Subject: NEW MODEL SERVICE CAUTIONS	Bulletin No: 00-002/12
	Last Issued: 04/03/2012

BULLETIN NOTE

2013 CX-5

Spark Plug:

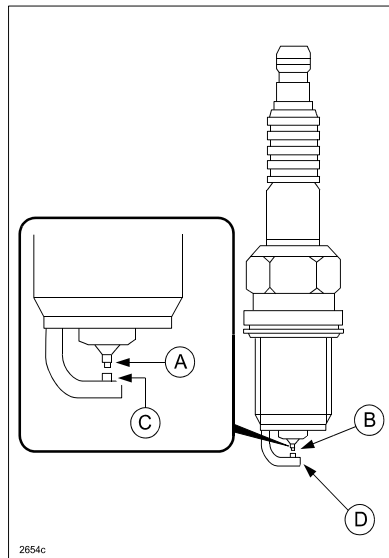
Only use the designated spark plugs for the SKYACTIV-G engine.

In order to achieve optimum ignition performance, SKYACTIV-G spark plugs use iridium (A) on an extremely thin center electrode (B) and platinum (C) on the ground electrode (D). Using general nickel or iridium plugs for the SKYACTIV-G engine could result in engine knocking, MIL illumination and/or poor driveability.

DTC U0151:00 Stored As Past Malfunction:

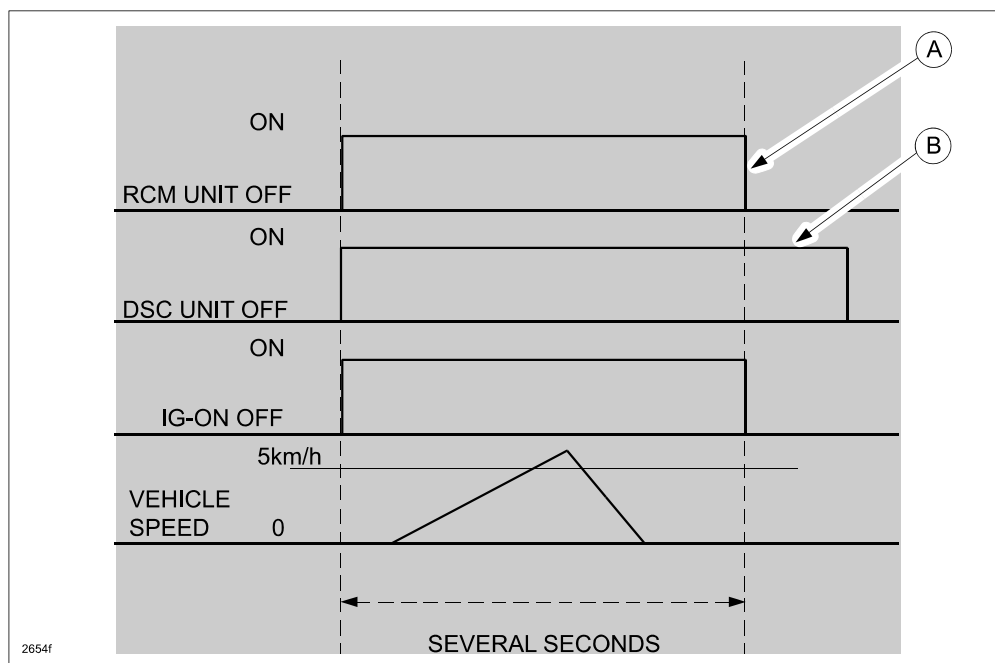
DTC U0151:00 ([DSC]: Communication error with SAS control module is detected in CAN communication) may be stored in memory as a past malfunction.

The DTC may be caused when the engine is started and the vehicle is driven immediately at 2 ~ 3 mph, then the ignition is turned off within several seconds.

While the DSC unit tries to communicate for a few seconds after the ignition is turned off, the RCM unit (SAS control unit) immediately stops communication when the ignition is turned off (A) at the self diagnosis stage. The DSC unit determines it as a communication error and sets the DTC as a result.

When the ignition is kept on longer than the self diagnosis stage (B), the RCM unit becomes able to communicate for a few seconds after the ignition is turned off, so the DTC will not be stored.

If DTC U0151:00 is found, check the following:

- Verify DTC U0151:00 is stored as a past malfunction.
- Other DTCs may also be stored that are not related to the symptom in this service information. Therefore, to eliminate DTC U0151:00, it is always recommended to check the service information independent from other DTCs.
- Check snapshot data item "IG-ON_TIMER" (time since ignition switch ON). Verify the time is between "00:00" and "00:08" (mm:ss).

When all of the above factors are applicable, it is normal operation of the DSC and not a concern that requires a repair. Clear the DTC and check whether it occurs again under normal driving conditions. If the DTC recurs, refer to the online instructions on MS3 or the Workshop Manual for further troubleshooting information.
